Revised Plan Sheet No. 1
TO ACCOMPANY CHANGE
Request No. 2 8/9/33

PLAN OF PROPOSED BRIDGES
ON
MURFREESBORO-NASHVILLE ROAD
PIKE COUNTY

JOB No 3161

BRIDGES NO. 1622, 1623 & 1029

DRAWING NO. 3207

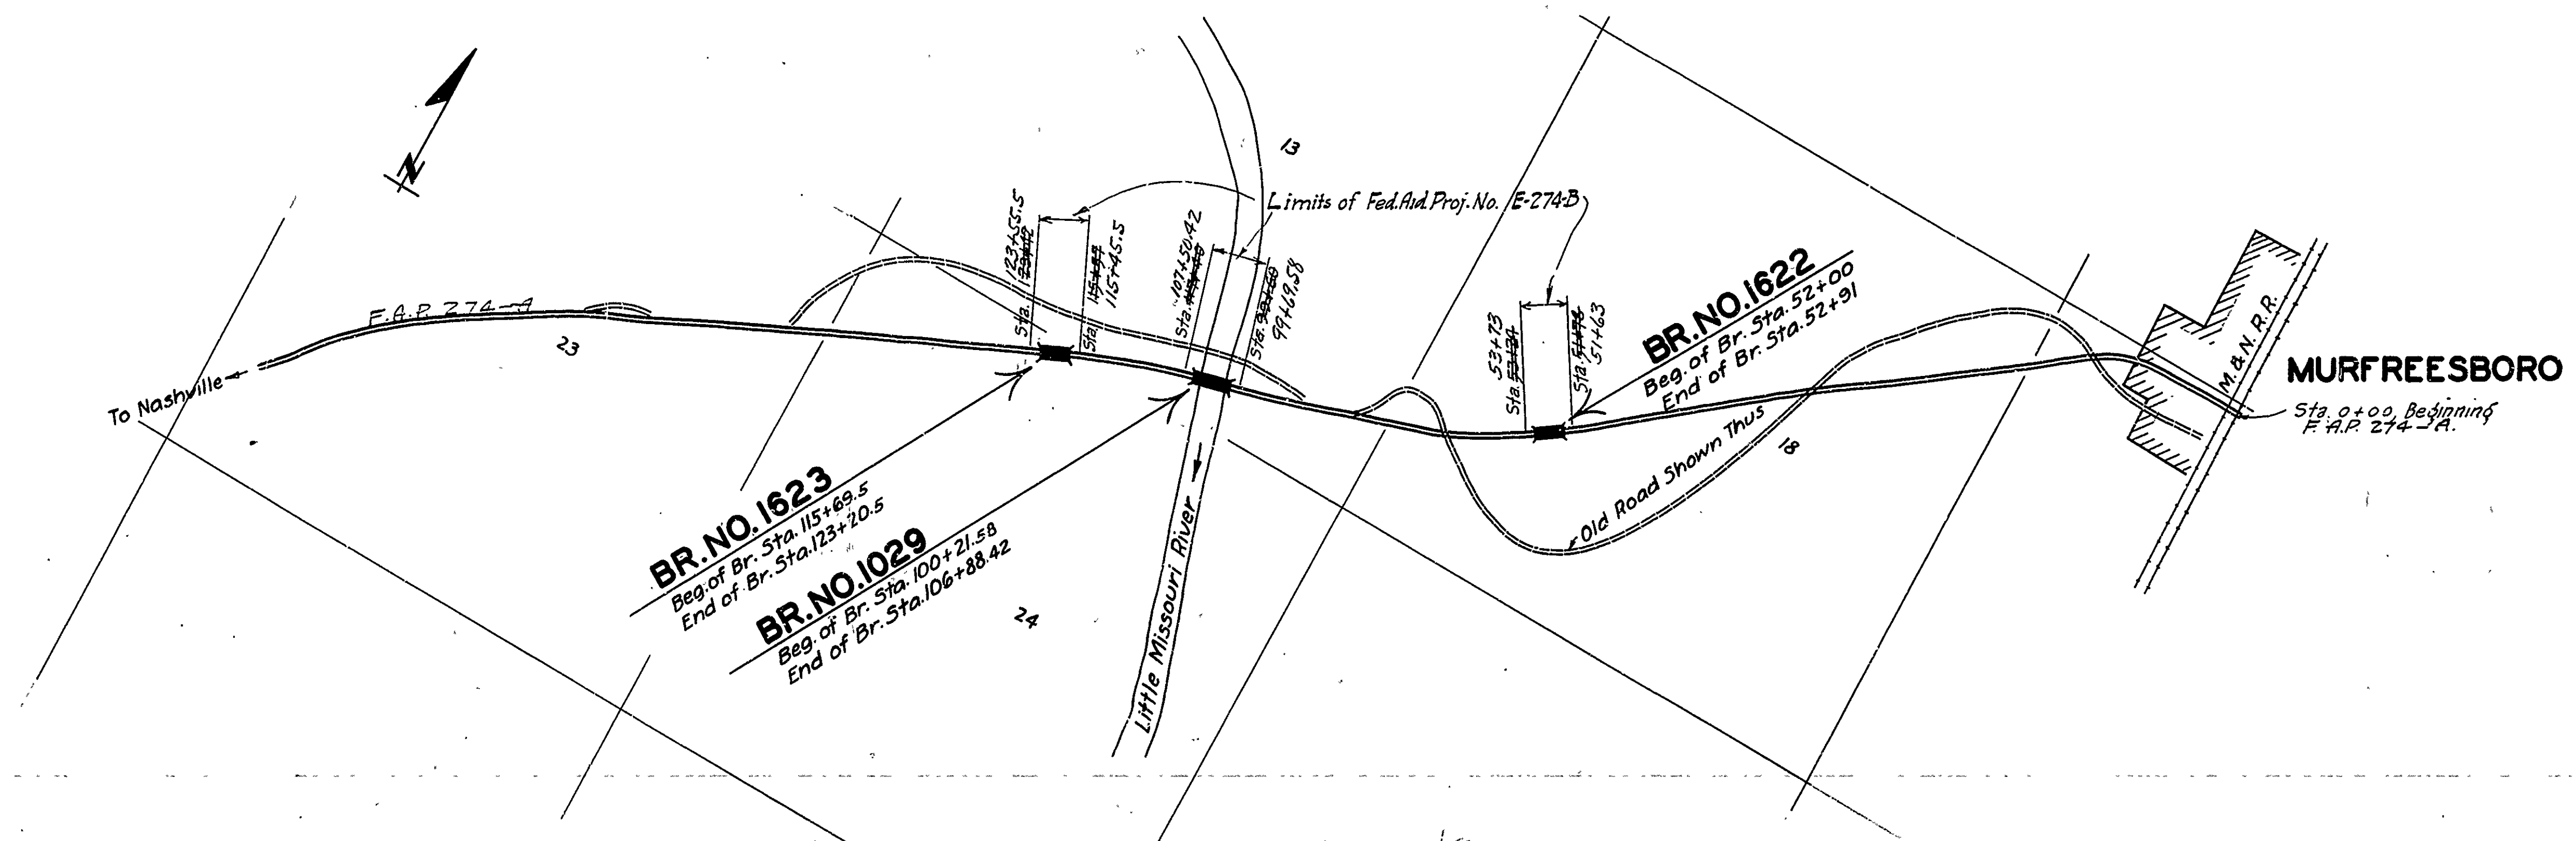
Fed. Aid bronze markers of approved design are to be furnished by the State. One project marker will be placed by the contractor at each of the following stations: ~~115+55, 123+73, 99+60, 107+40, 115+55, 123+73~~ 51+63, 53+73, 99+69.58, 107+50.42, 115+45.5, 123+55.5
